**Re: Response to Comments  
90% Design – Slip 3 Containment Alterations  
OMC Superfund Site, Waukegan, Illinois**

## CONTAINMENT ALTERATION / BOAT STORAGE RE-USE

### WAUKEGAN HARBOR SLIP 3 SITE

100% DESIGN SUBMITTAL  
OCTOBER 2007

SHEET 1 of 13

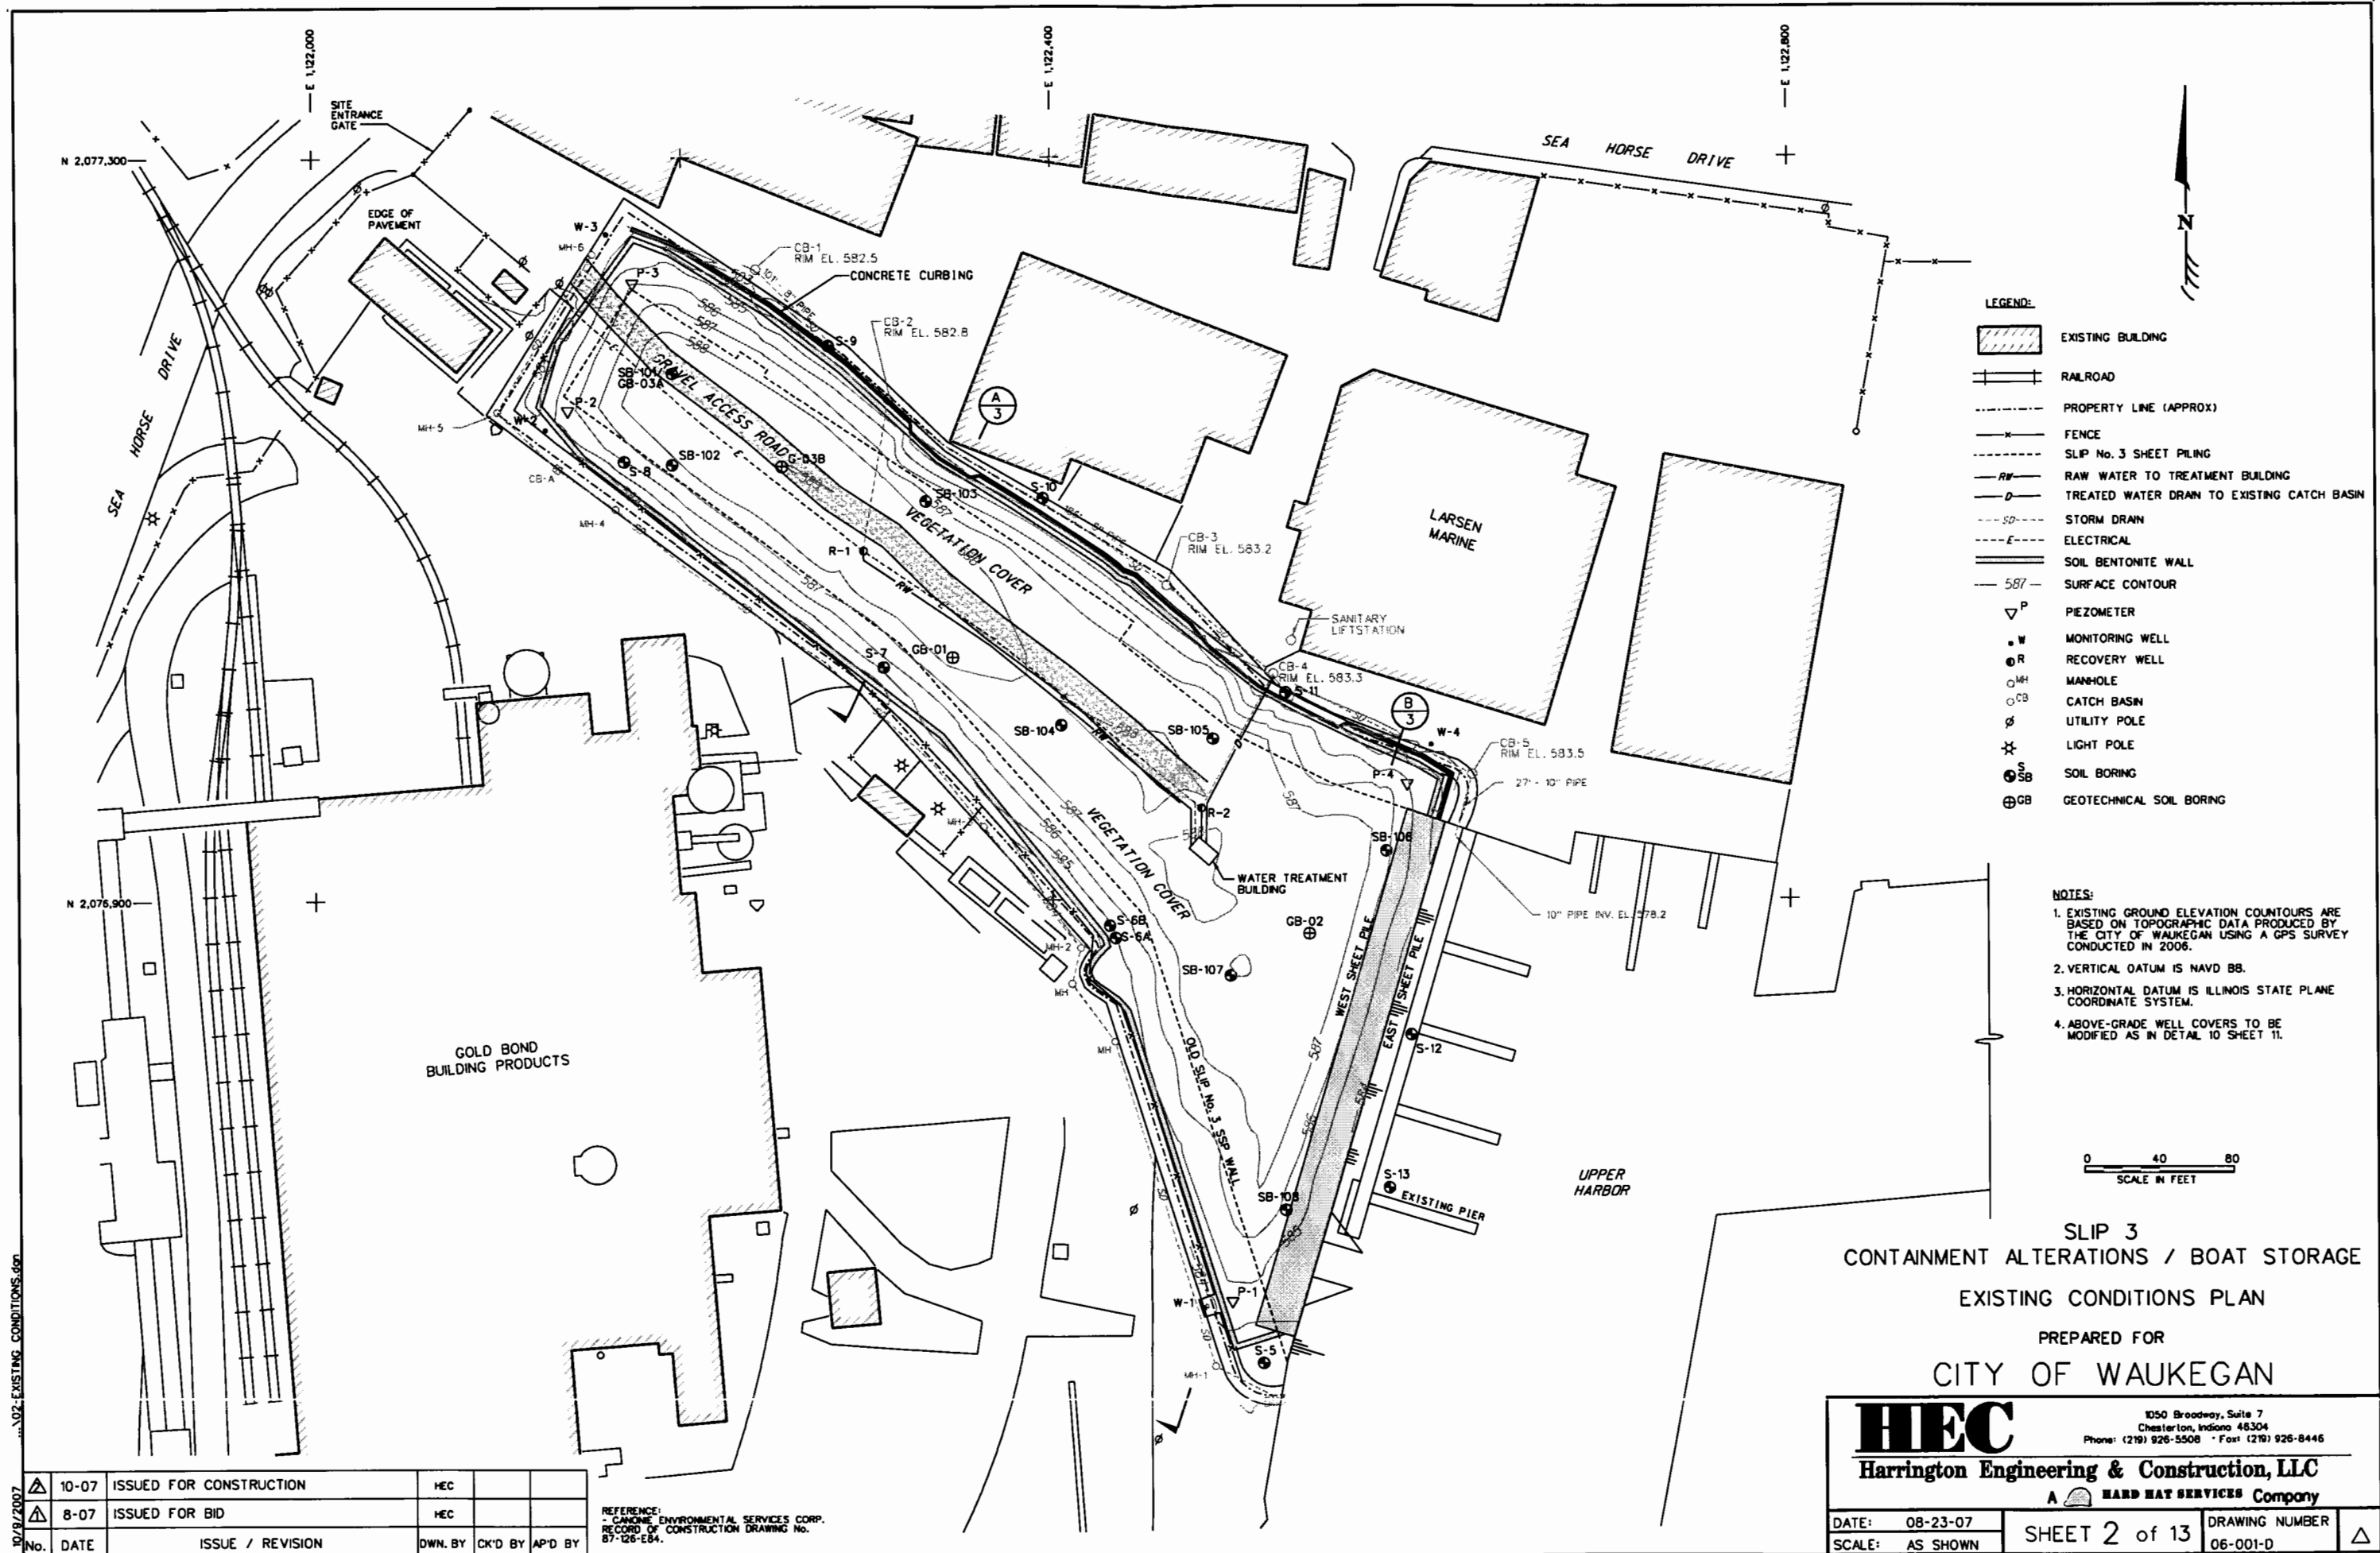
1. **Sheet 4. Note 11.** *This states that the topsoil and sand will be stockpiled at the City of Waukegan property location on Sheet 1. There is no proposed location identified on Sheet 1.*

Sheet 1 is revised to show the stockpile location on the City property.

## SLIP 3 CONTAINMENT ALTERATIONS / BOAT STORAGE EXCAVATION PLAN

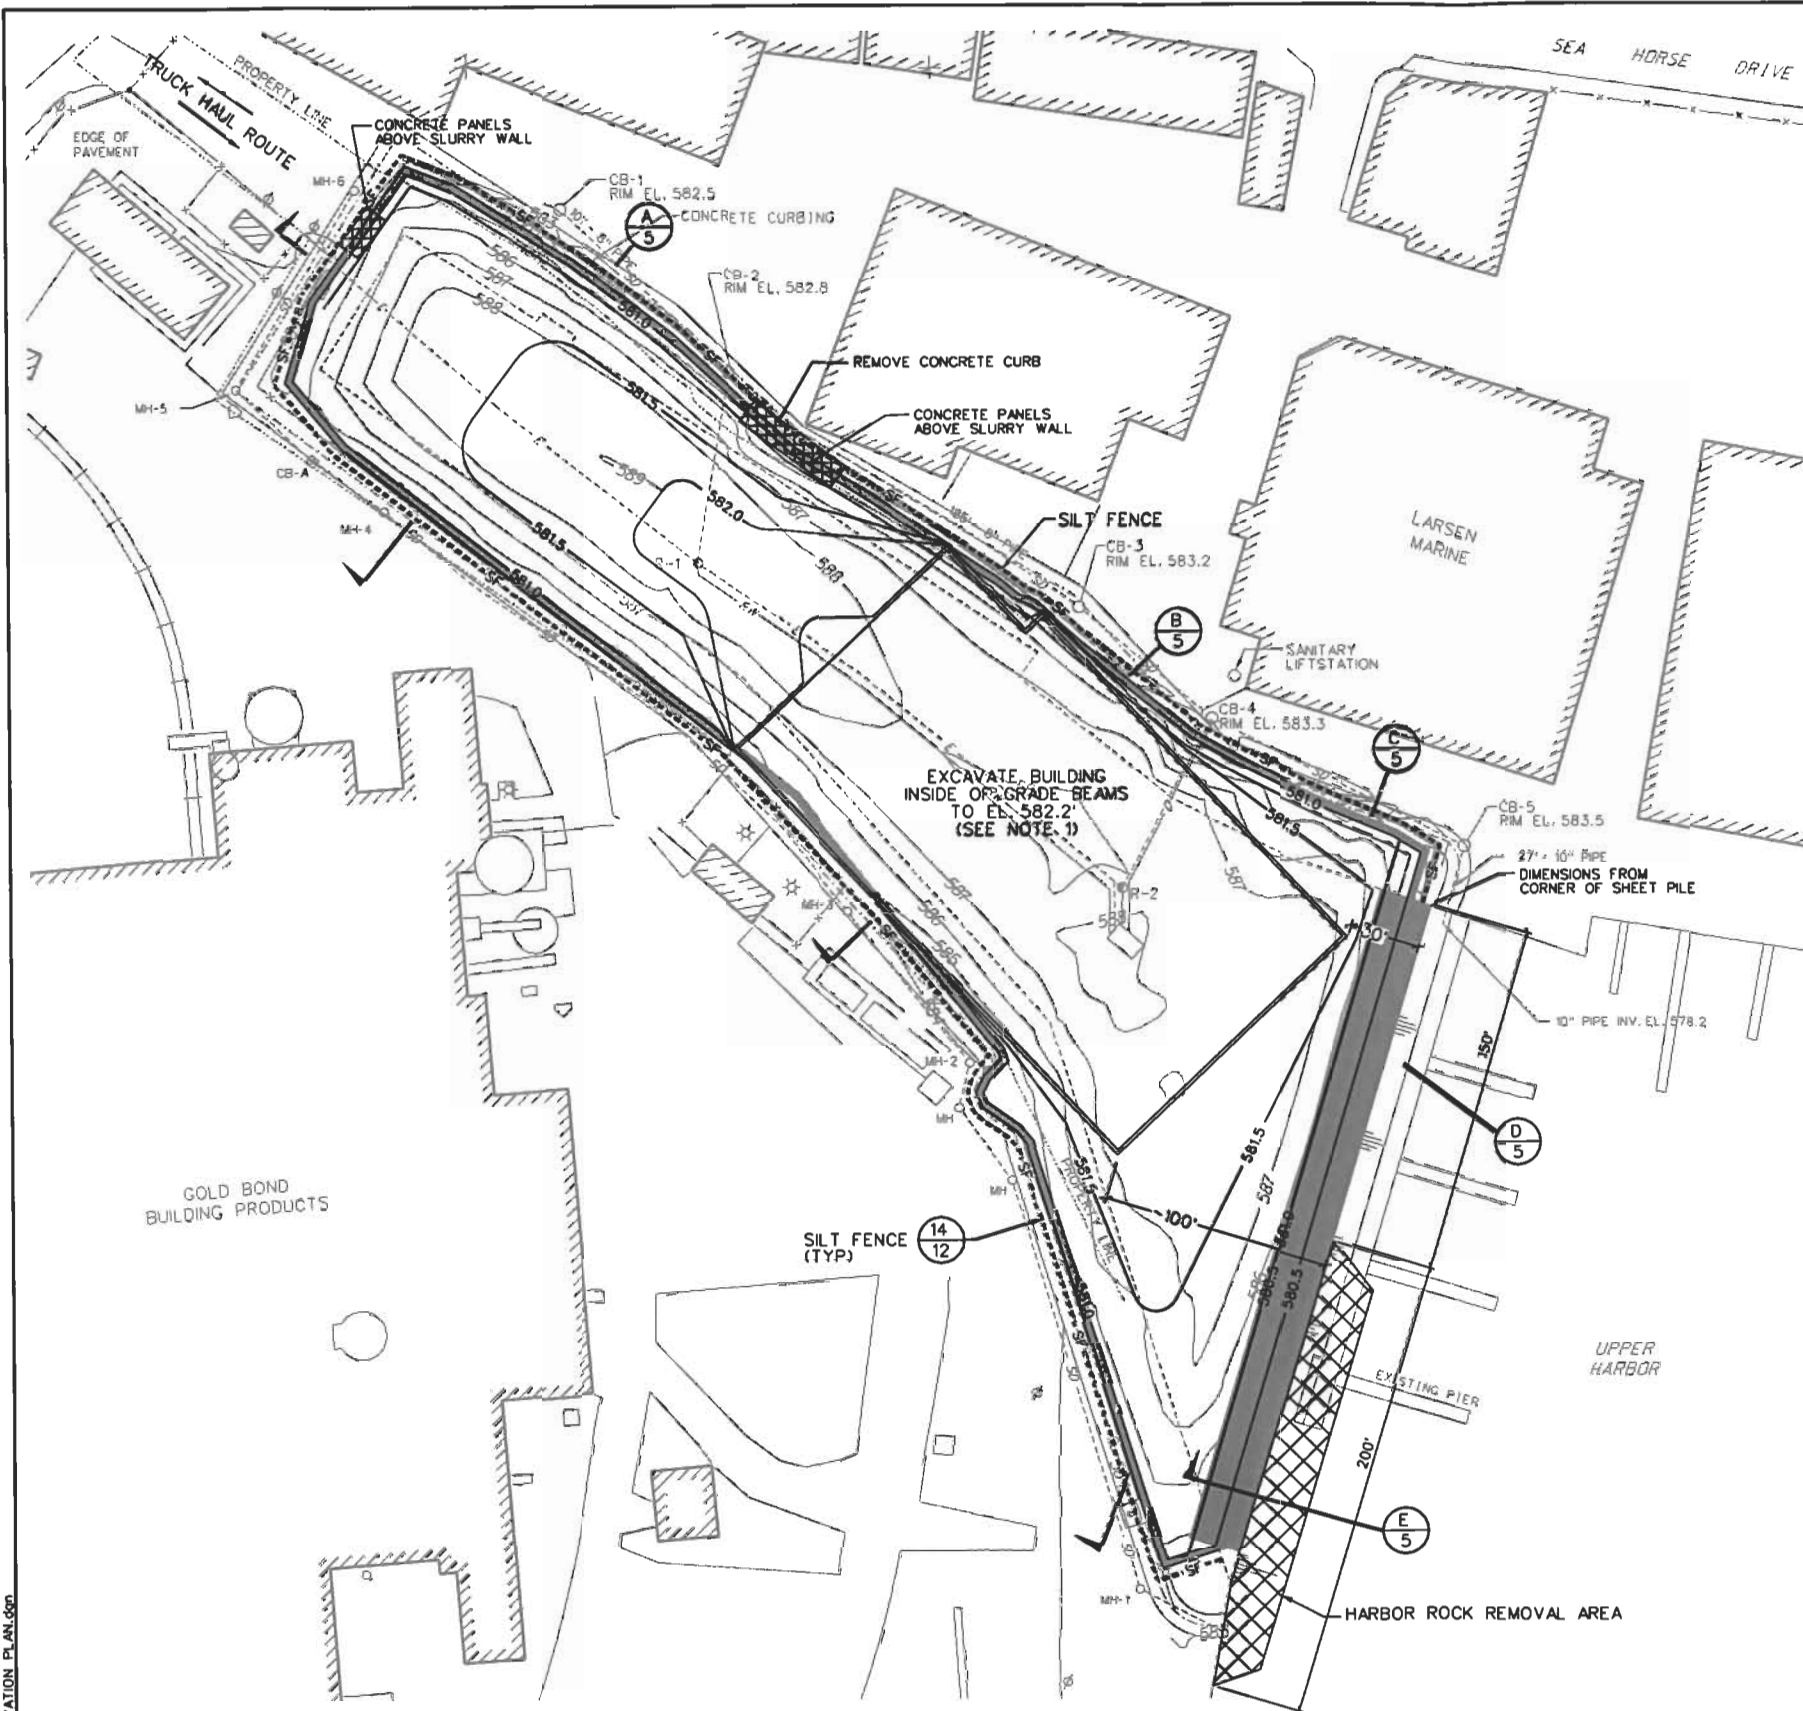
- 1. Slip 3 was constructed to provide a containment cell for TSCA level contaminated dredge sediment from the harbor in excess of 50 ppm and up to 500 ppm PCB. Therefore, the contaminated material below the surcharge sand should be handled, including proper worker PPE and exposure precautions, and disposed of in accordance with TSCA 40 CFR 761.*

While significant excavation into the PCB-contaminated sediment is not anticipated, a note is added to Sheet 4 stating that materials excavated from below elevation 581.0 will be considered TSCA material and must be handled, transported, and disposed of at a TSCA-approved landfill, in accordance with TSCA 40 CFR 761.

SLIP 3  
 CONTAINMENT ALTERATIONS / BOAT STORAGE  
 TOP OF LINER PLAN

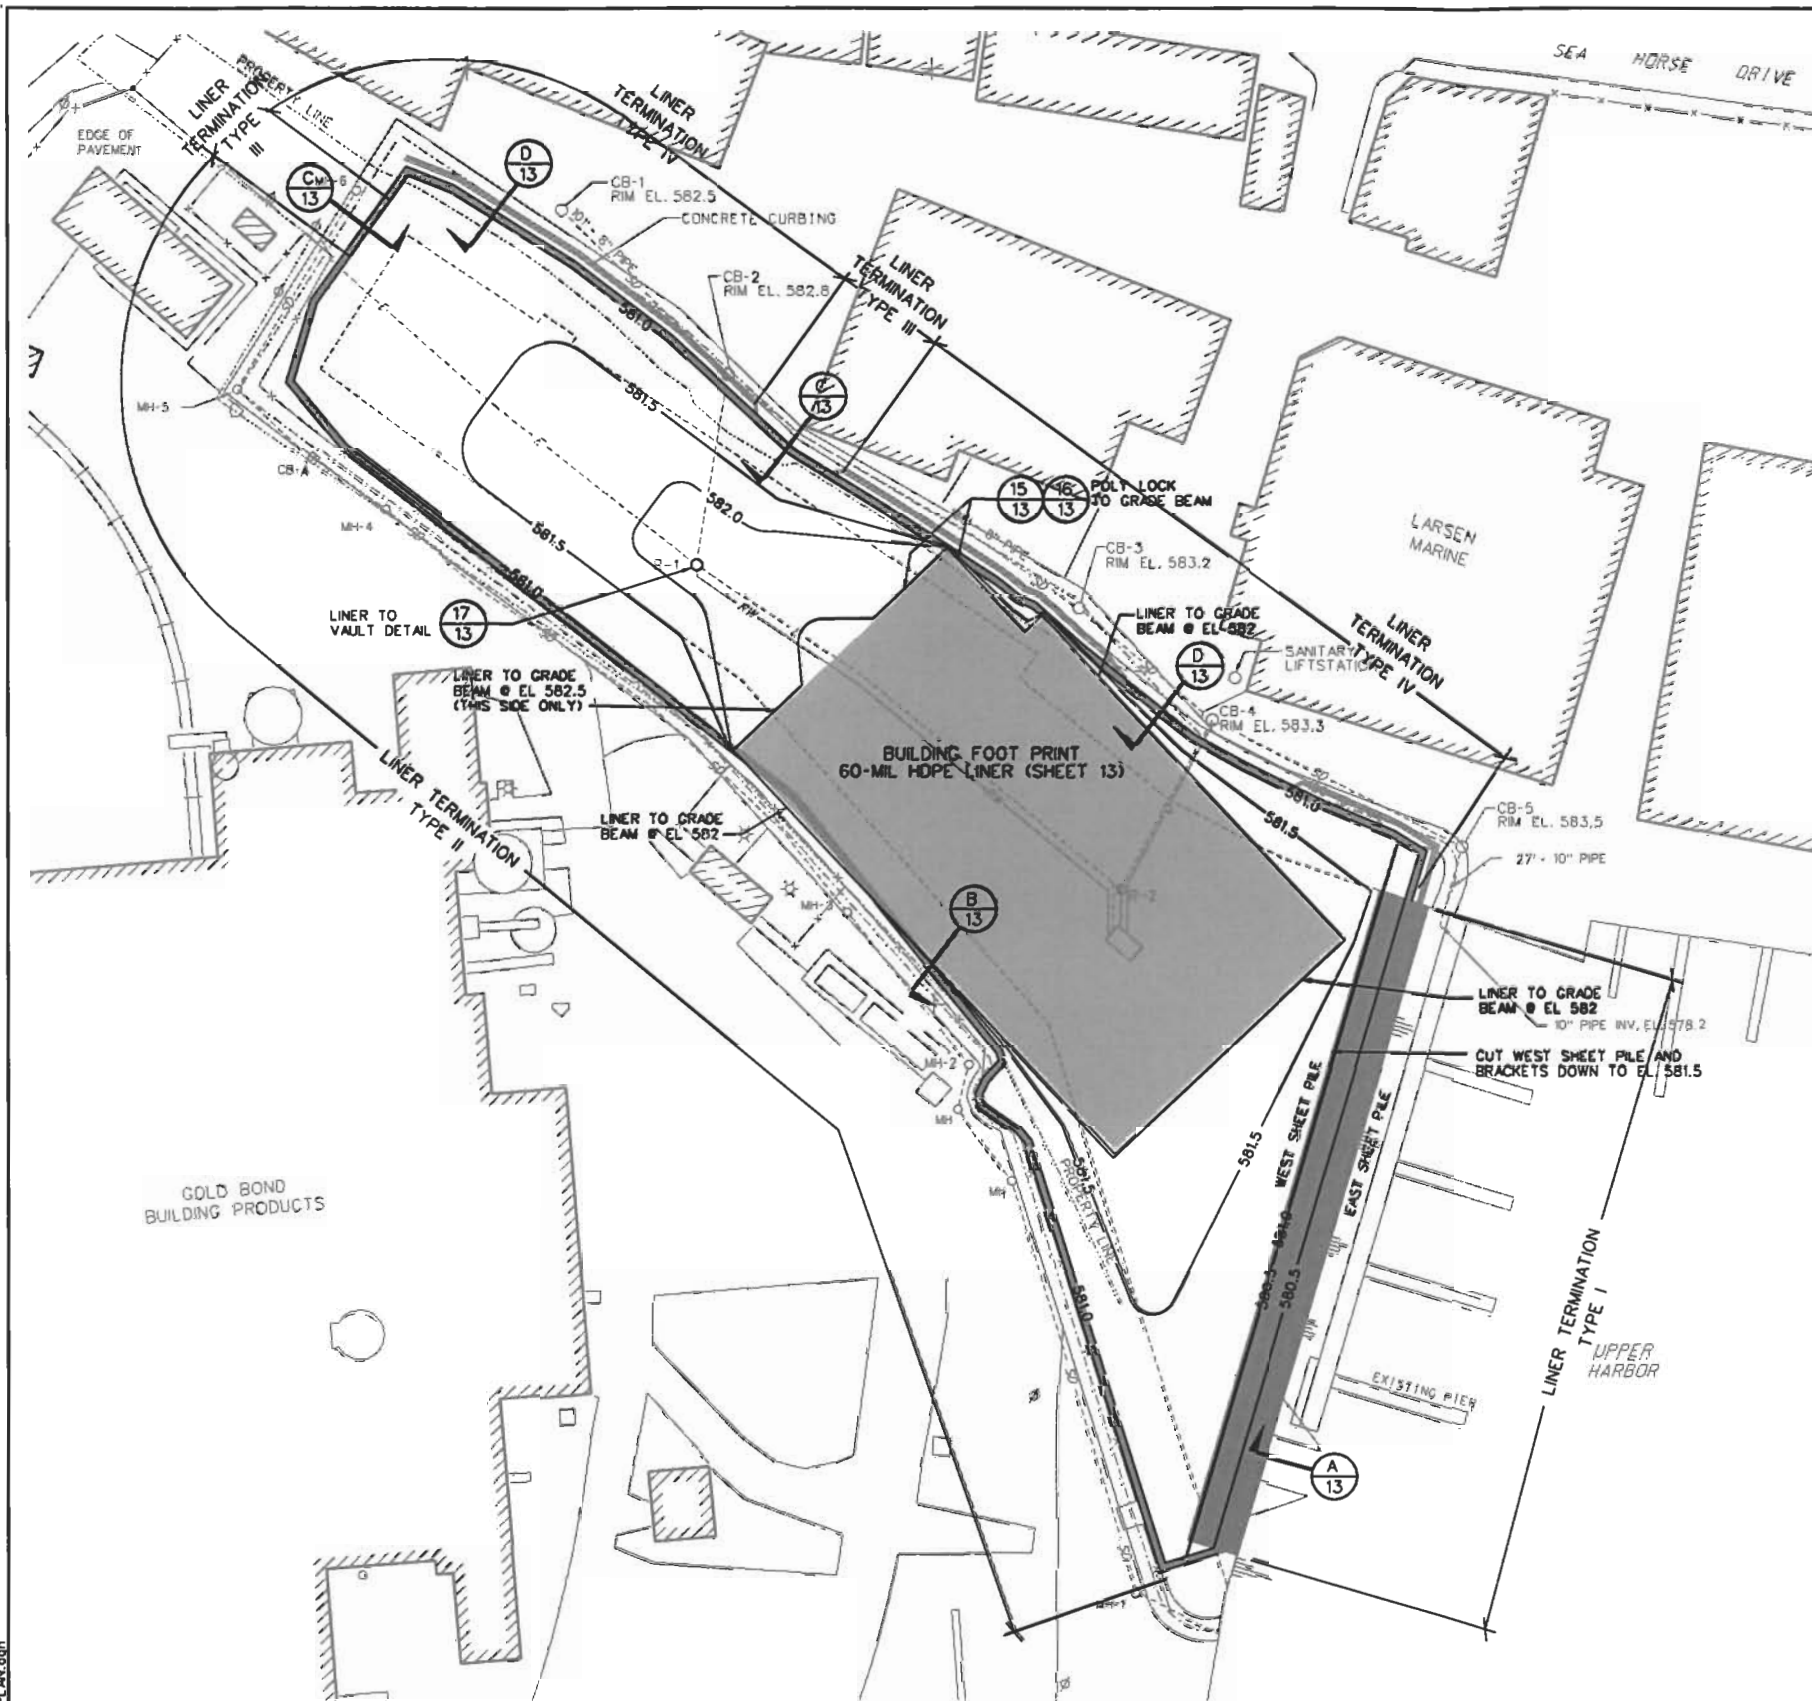
- a. *The area under the building is shaded and noted to be the "60-MIL HDPE LINER." Presumably the remainder of the area enclosed within the slurry walls and the east sheet pile wall will also be provided with a 60-mil HDPE lining; the details on Sheet 13 imply this. This should be clarified.*
- b. *Is there any slope the HDPE liner under the building? Where will drainage from the geocomposite drainage layer be discharged?*

The 60-mil HDPE liner is continuous outside of the building footprint within the area enclosed by the slurry wall. The shading note is changed to indicate that the liner under the building is a separate liner fastened to the inside of the grade beam for the building and is placed at elevation 582.2 feet with no sloping grade.

There is no slope to the HDPE liner under the building and there is no location for the geocomposite drainage layer to discharge because of the grade beam. The HDPE liner is not acting as the primary containment element to prevent the influx of surface water into the containment.

Notes concerning puncture protection are added to Sheet 8 – Top of Liner.
